October 12, 1994  
1063-1, MV101204

**RE: ADDENDUM TO APRIL 27, 1994  
WORK PLAN  
S&S BUILDING SUPPLY  
SAN LEANDRO, CALIFORNIA**

**SITE PLAN**

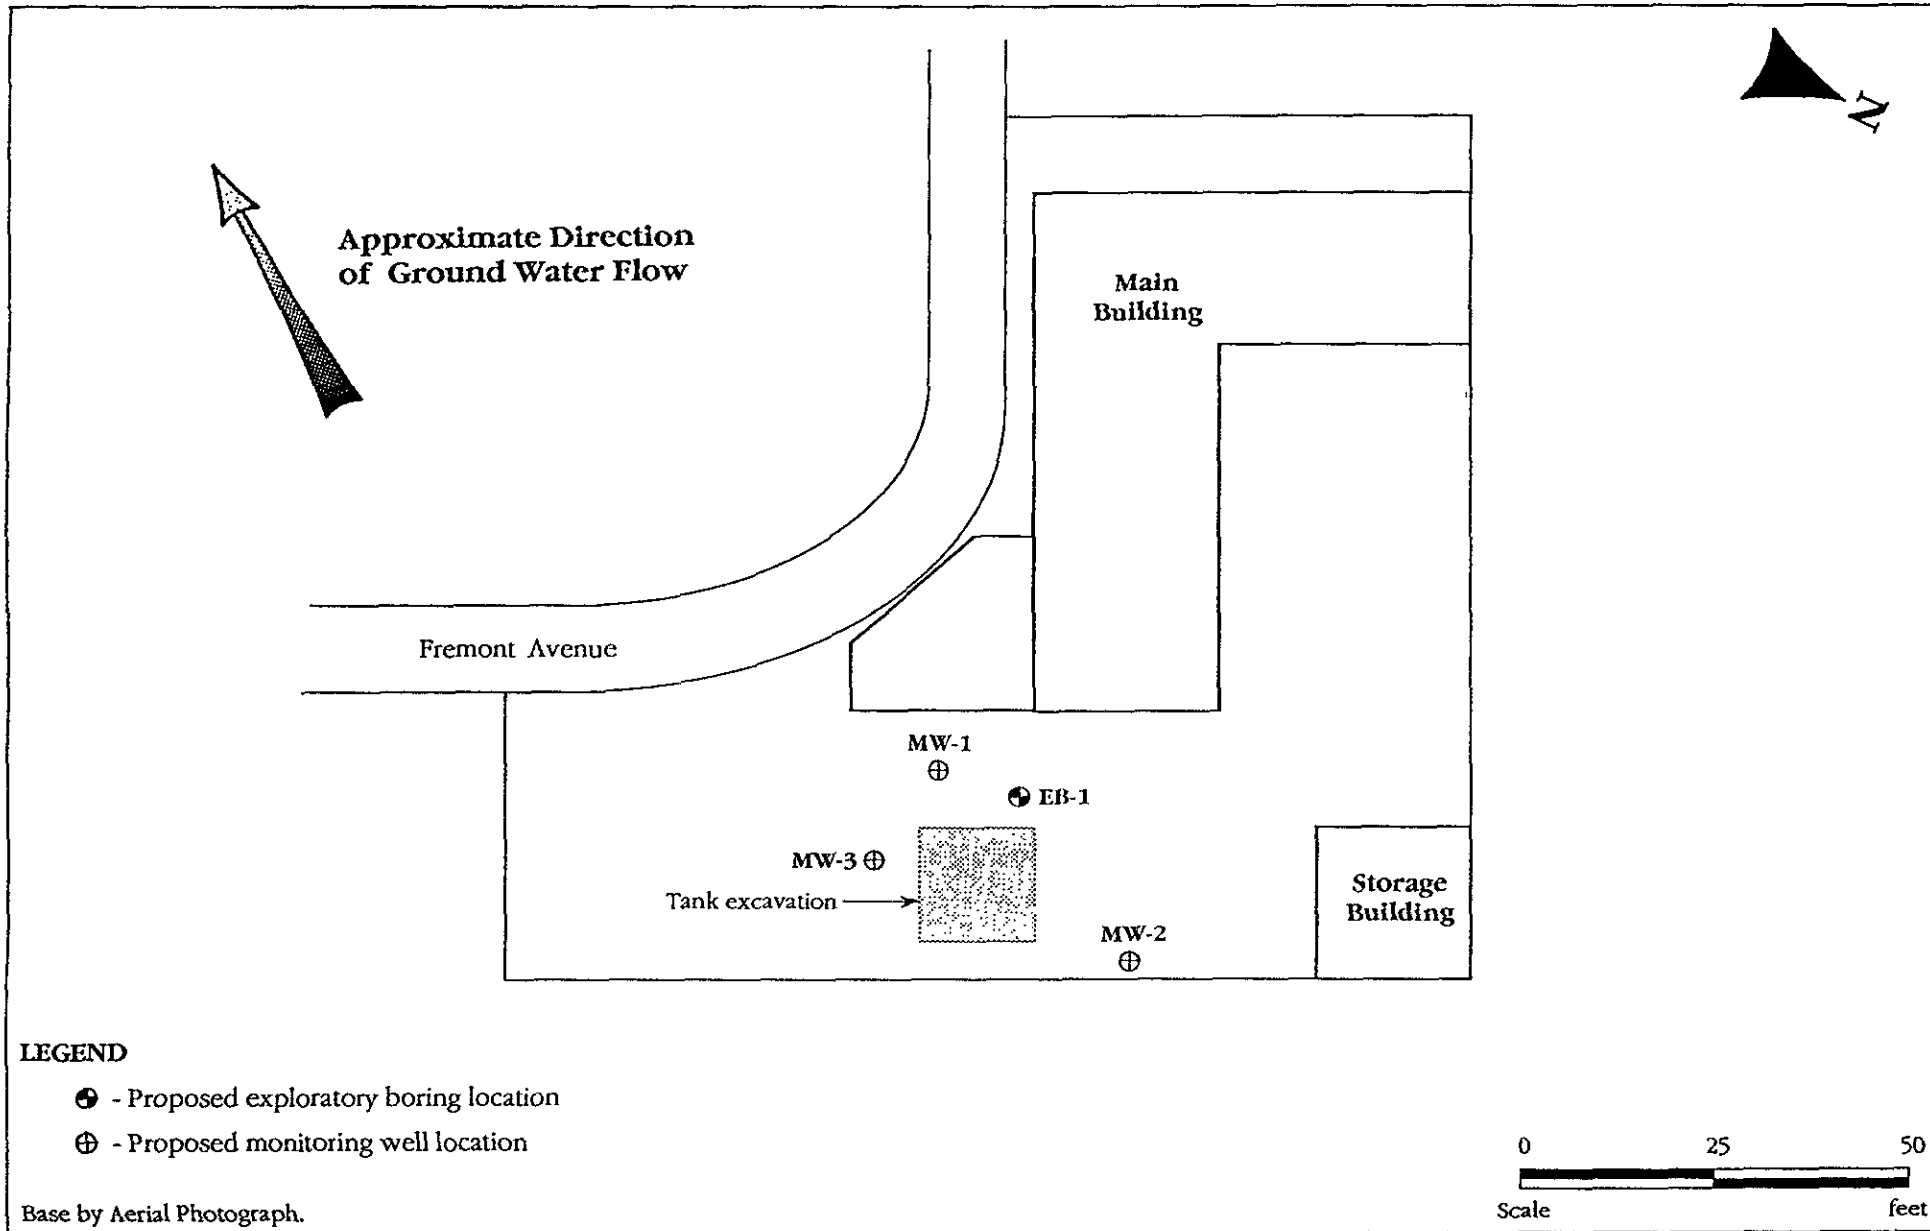
- ✓ ▼ A map showing proposed boring and well locations is attached as Figure 1.
- ✓ ▼ In addition to standard sampling protocol procedures presented in the April 1994 work plan, one duplicate soil and ground water sample will be submitted for analysis. The laboratory quality control data report, as well as the results of the duplicate samples, will be included in our final report.

- ✓ ▼ According to Mr. Rick Montesano of Paradiso Construction Co., after the tank removal, the excavation was extended to ground water at a depth of approximately 10 to 12 feet. Reportedly, no sidewall samples were collected for analysis. Based on this information and in agreement with your recent letter, drilling of a boring within the former tank pit does not appear warranted. The proposed boring will alternatively be located approximately

5 feet west of the excavation as shown on Figure 2. Soil samples collected from monitoring well borings MW-1 and MW-3 will further aid in evaluating the lateral extent of impacted soil. As you may recall, petroleum hydrocarbons were not detected in soil samples collected beneath the tank formerly located within the eastern portion of the excavation; thus, drilling of a boring on the eastern side does not appear warranted, in our opinion.

WELL CONSTRUCTION DETAIL

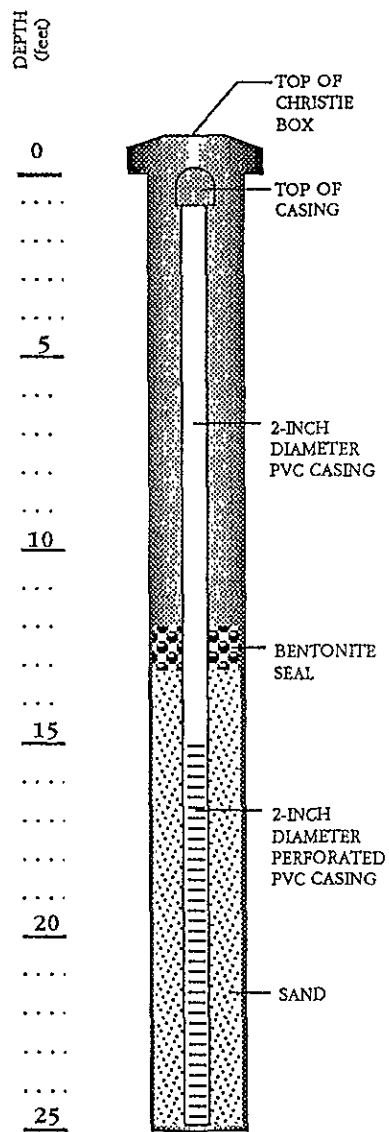
- ▼ Well construction specifications and a schematic well construction diagram are attached.
- ✓ ▼ The monitoring wells will be surveyed to an established benchmark located at the intersection of Fremont Avenue and Floresta Boulevard to the accuracy of 0.01 foot, with elevations measured relative to mean sea level.

It is anticipated that the bottom of the wells will be at a depth of 25 feet. A 10-foot length of slotted casing will be used in each well. Blank casing will be used to construct the remainder of the well to within 0.5 foot of the ground surface.

A sand filter pack and 0.02 slot size PVC screen will be selected to limit the amount of native filter pack material entering the monitoring well. The filter pack will be placed at least 2 feet above the top of the well screen and a 1-foot thick bentonite seal will be placed on top of the sand. A cement slurry seal will be placed above the bentonite seal to within 0.5 foot of the ground surface. A schematic well construction detail log is included with this attachment.
